## **Jupiter turbine layout.**

The proposed layout of the Jupiter wind farm must be peer reviewed.

Appendix B – Liverpool Range Wind Farm Layout

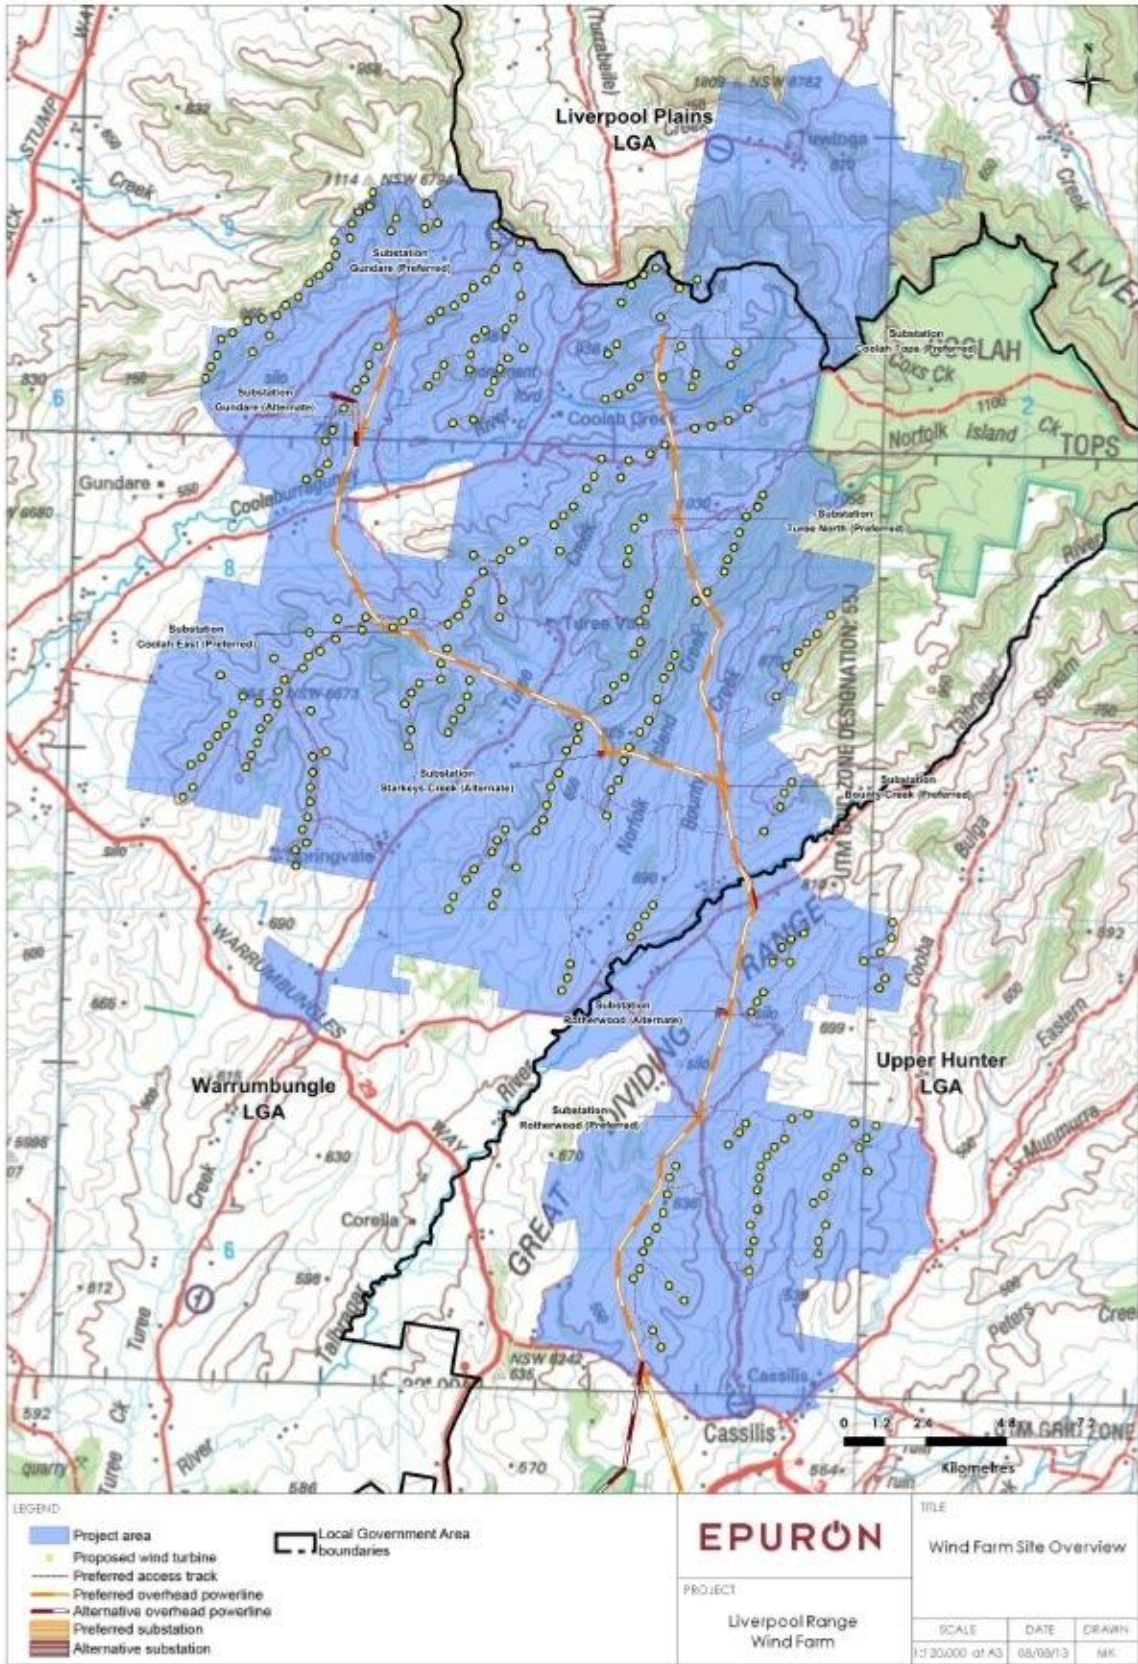
Compare this, for instance to the layout of the Capital 1 and 2 windfarms. See Appendix A.

Capital turbines are strung in rows perpendicular to the wind direction. (See Appendix B for a similar layout pattern for the Liverpool Range Wind Farm) Whilst the Capital turbines in a row are close together (approx 400 -500 metres) the rows are over a kilometer apart. There is a fundamental reason for this as explained in a 2013 article from the University of Adelaide.

Let us compare the Capital 1 (operating) and 2 (approved) layouts to that for Jupiter in the current EPYC newsletter. Let us assume that 10 rotor diameters is an average practical distance between wind facing rows. For Capital 2, with a rotor diameter of 114 metres, this equates to 1.14 Kms, which is what the design shows.

For the Jupiter layout, there are no "rows" as such, but if we take the east-west string of 6 turbines closest to the Barnet subdivision, we find they are, on average less than 500 metres apart. Practical turbine placement would see that these turbines should be 10 x 126 Mts (published Jupiter turbine maximum diameter) = 1.26 Kms.

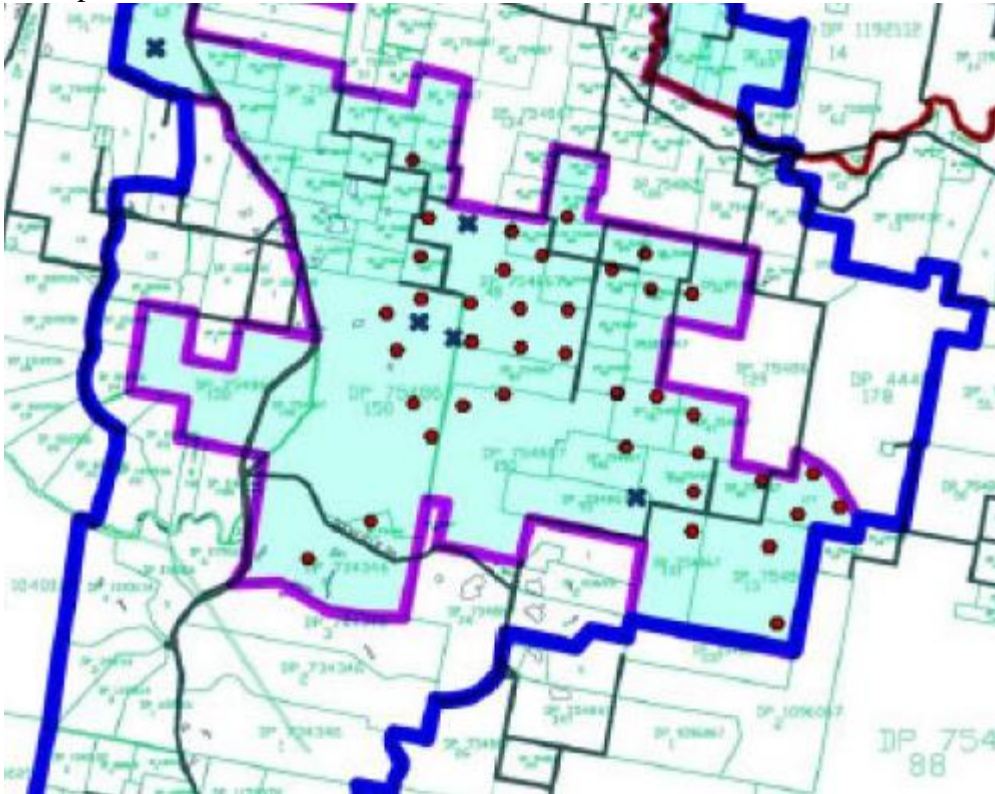
The “east-west string of 6 turbines closest to the Barnet subdivision” became a string of 4, the two “X”s next to each other representing turbines that had been removed.

Why were they removed? What were the technical reasons?

The layout in the current EIS is also fundamentally unchanged. None of the 4 turbines have been moved to take advantage of the freed up space and thus improve efficiency.
